GOVERNMENT OF THE DISTRICT OF COLUMBIA
DEPARTMENT OF GENERAL SERVICES

DESIGN AND INSTALLATION OF LOW IMPACT DEVELOPMENT STORMWATER
MEASURES AND OUTDOOR EDUCATION FEATURES AT
THREE DISTRICT OF COLUMBIA SCHOOLS

Solicitation #: DCAM-13-CS-0004

Addendum No. 2
Issued: October 22, 2012

PRELIMINARY SCHOOLYARD DESIGN

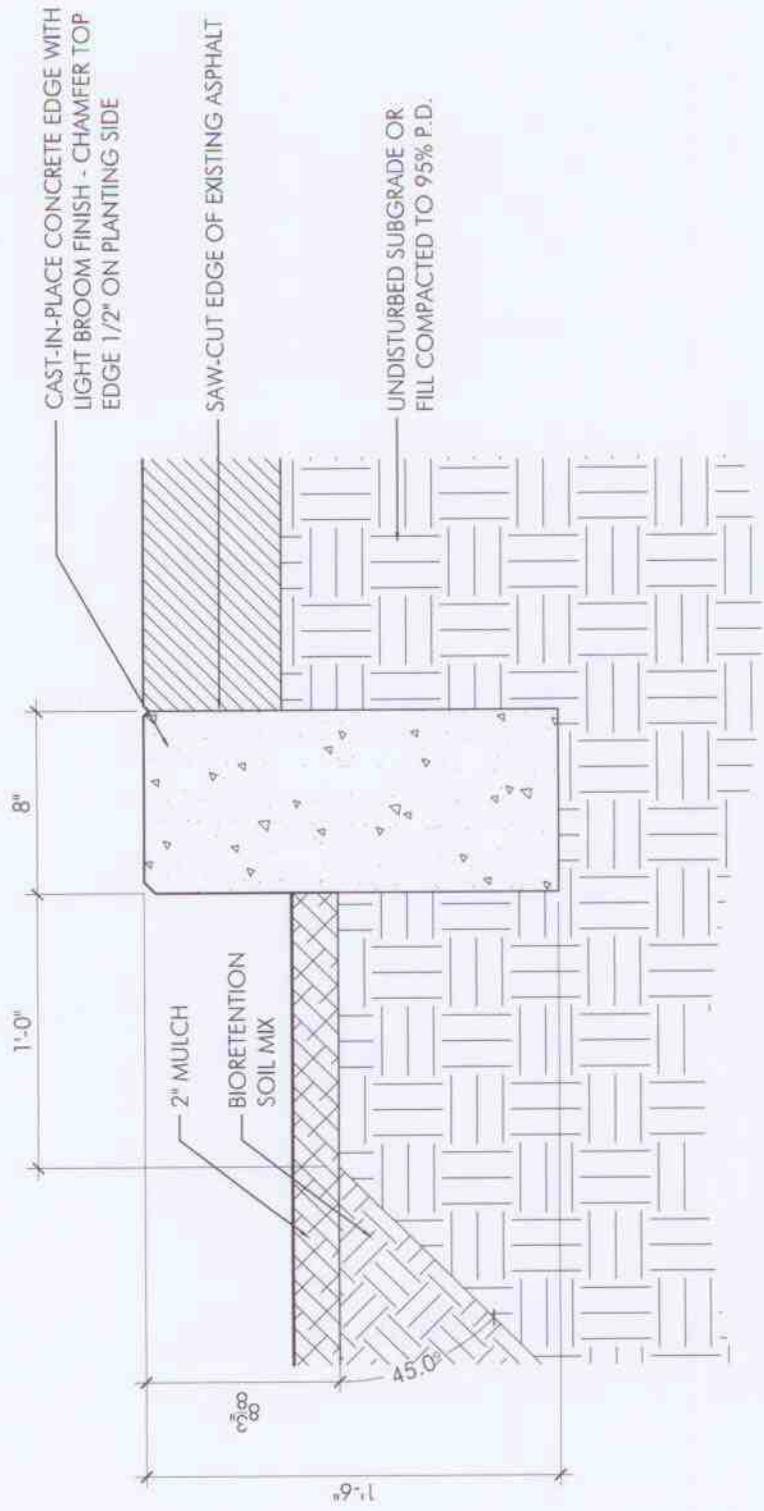
SURVEY AND GEOTECH REPORT: As mentioned at the site visit, although this project will not be done to meet stormwater requirements, the plans will still need to go through a courtesy stormwater review at DDOE. What will be required is an abbreviated survey of the drainage area and a brief geotechnical report. Additionally, a perc test at two locations (minimum) will be required to get an assessment of infiltration rates. For bioretentions with under drains, perc tests are not necessary. This will need to be completed prior to the designs being accepted. Retention volumes must be calculated and DDOE expects this bioretention to capture the 1.2" inch event.
